# Architect's Supplemental Instructions

Police Department Midtown District

ASI Number 004

1/25/2018

**Site Plan**

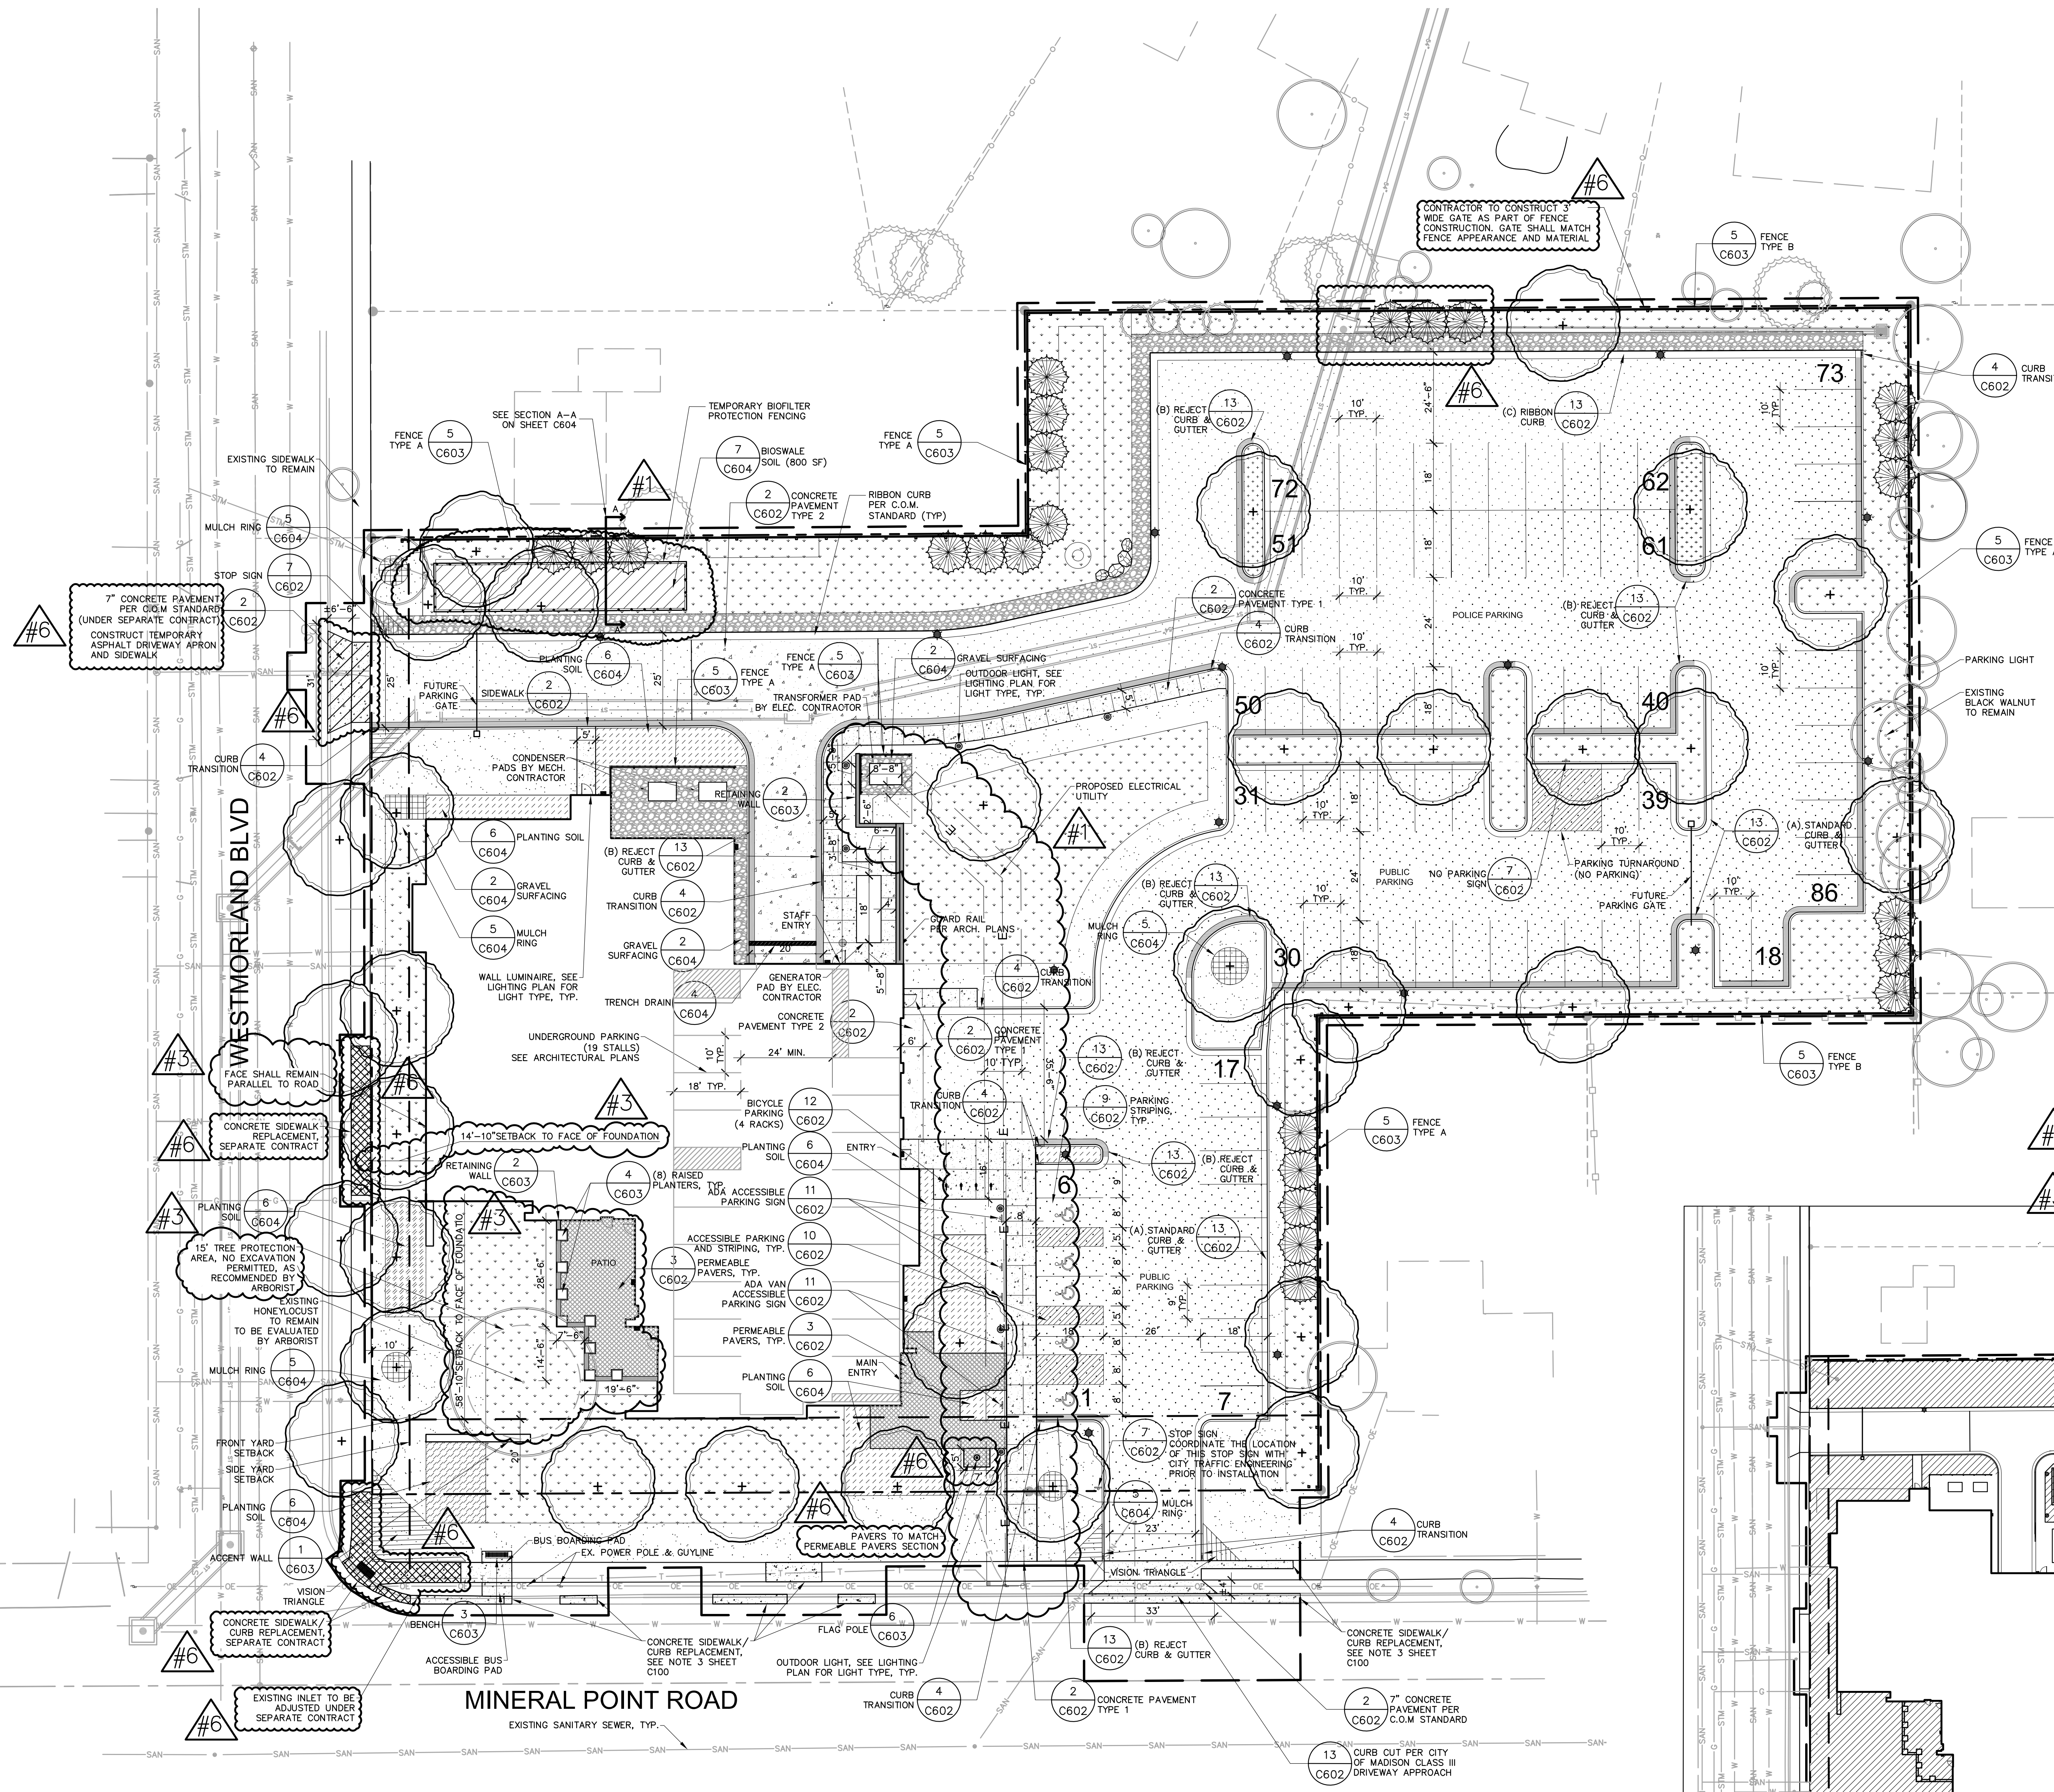
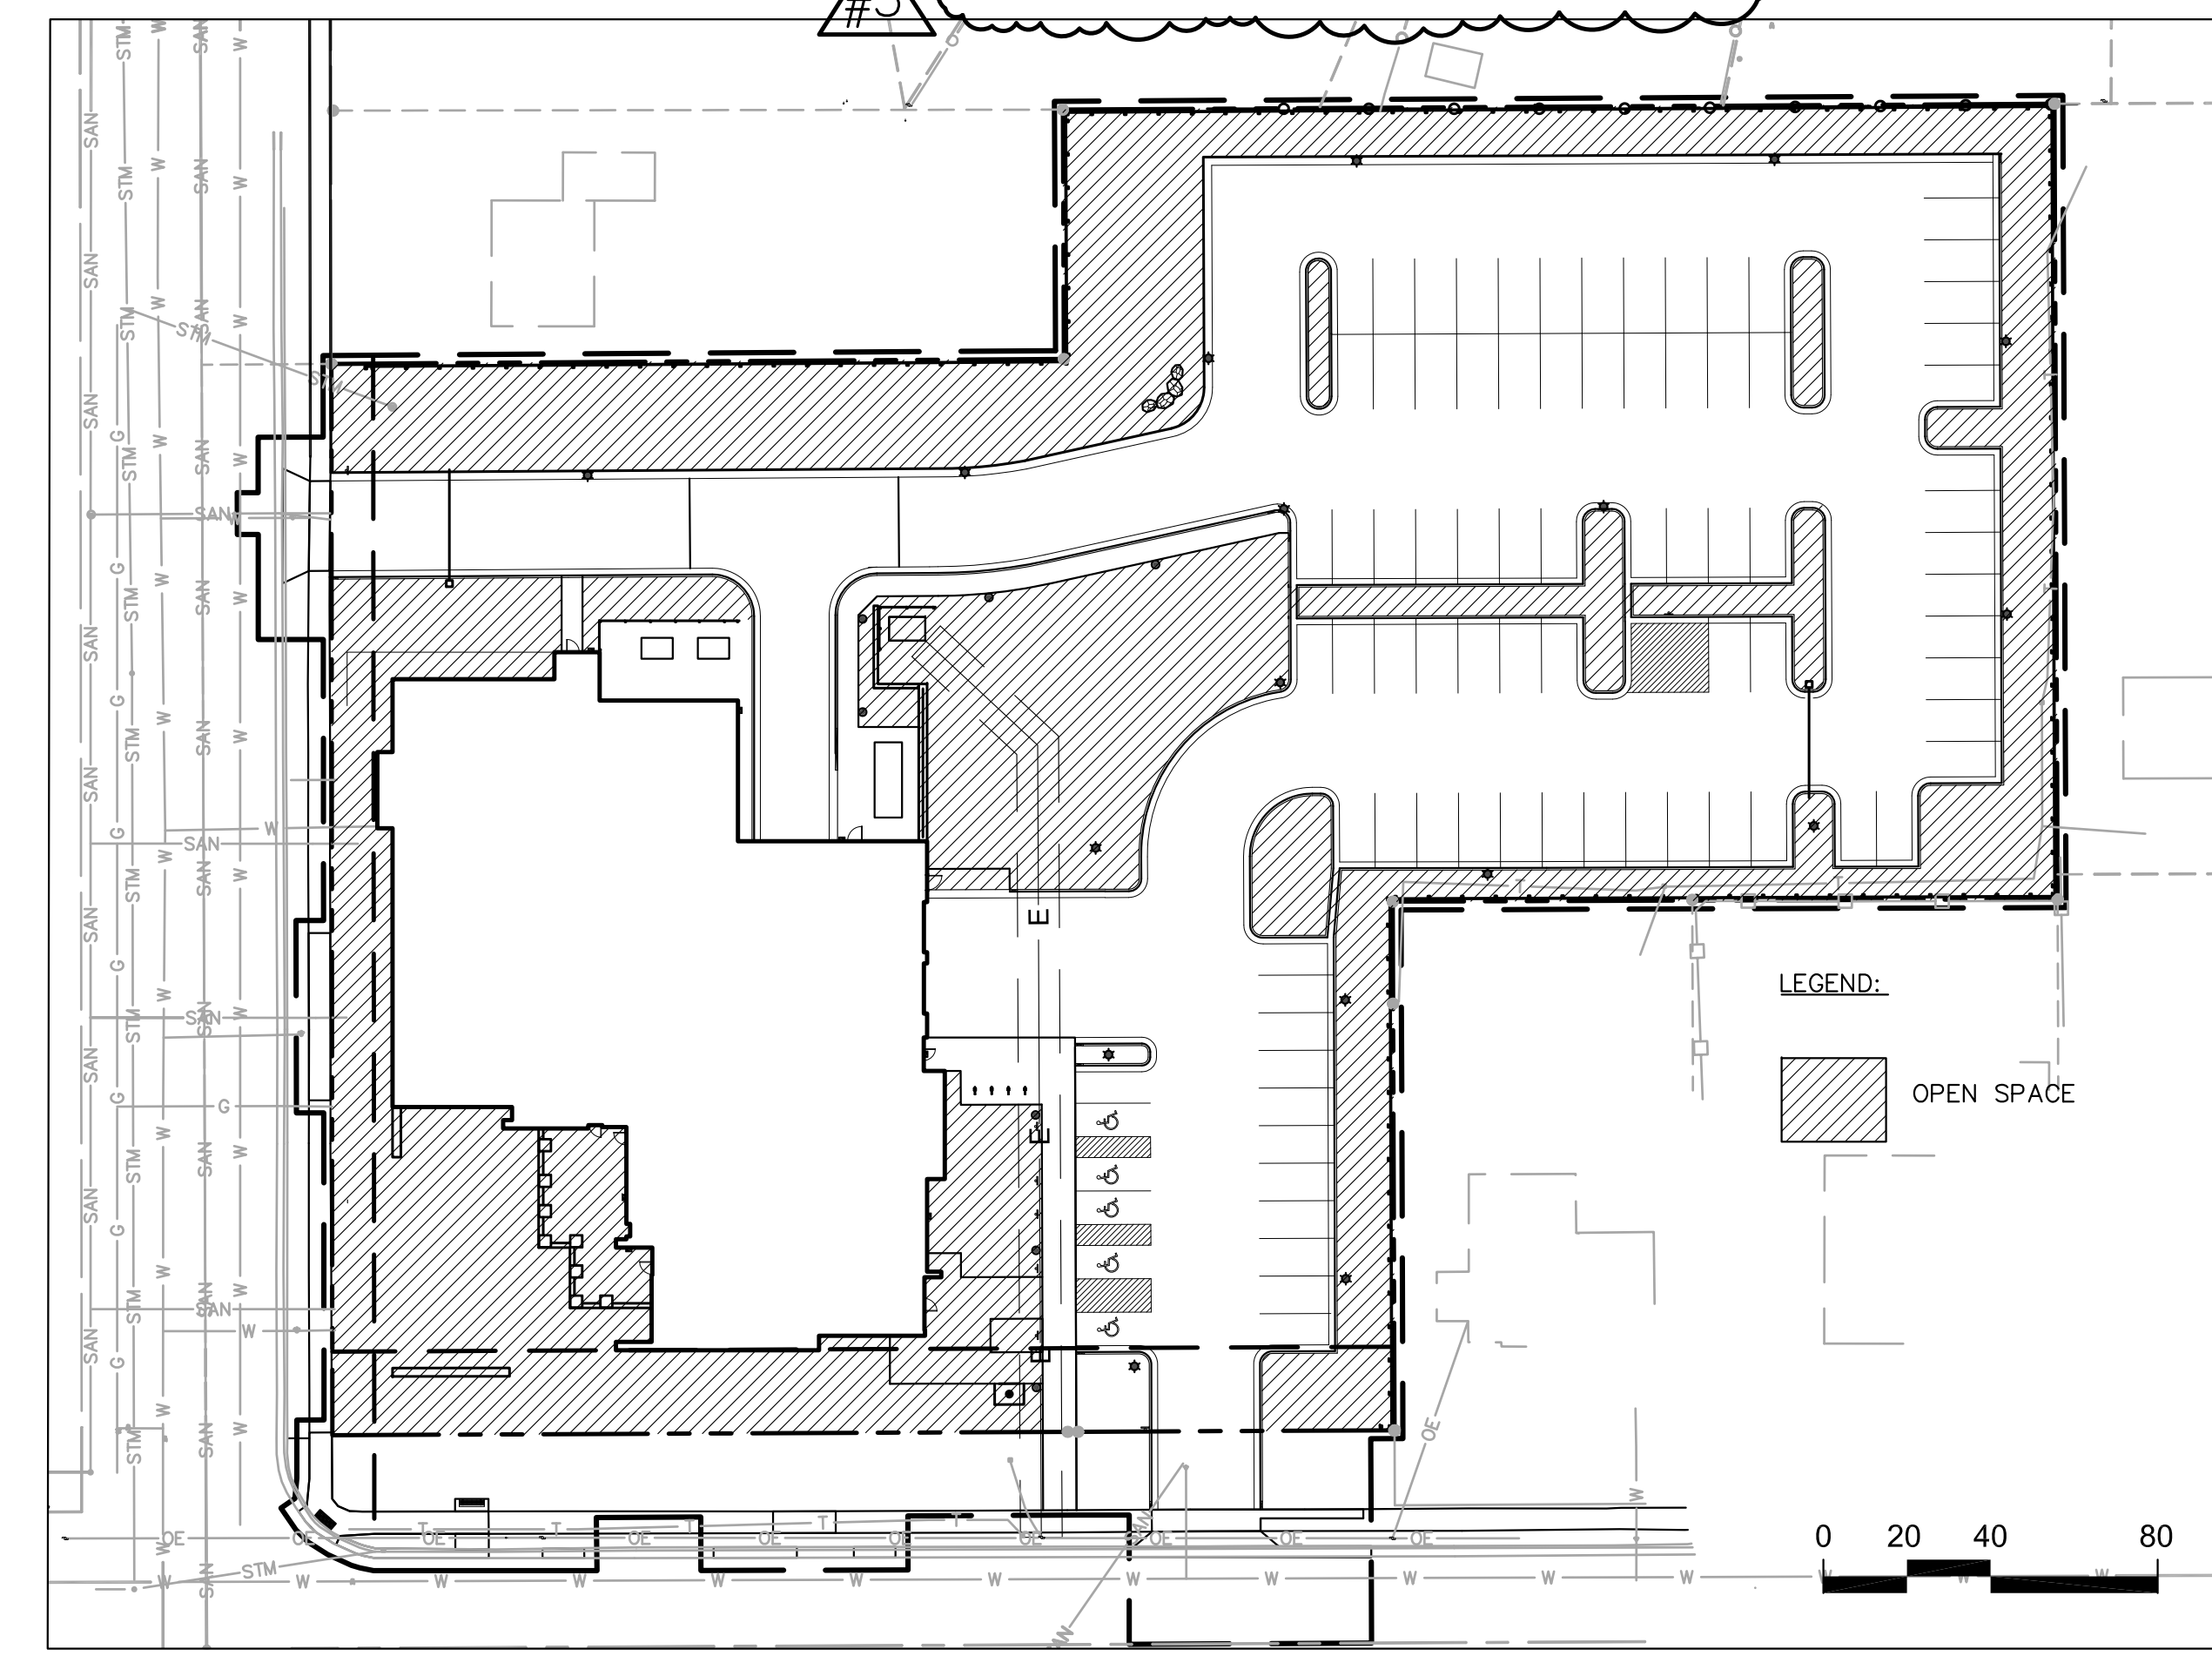
7. The attached sheet C200 has been reissued with the following revisions:
  - A. New concrete sidewalk, curbs and apron that have been removed from the project to be done by others.
  - B. Flagpole has been moved with additional pavers to be placed around the base.
  - C. Addition of a 3'-0" wide gate to the North property for access to cleanout in neighbors yard.
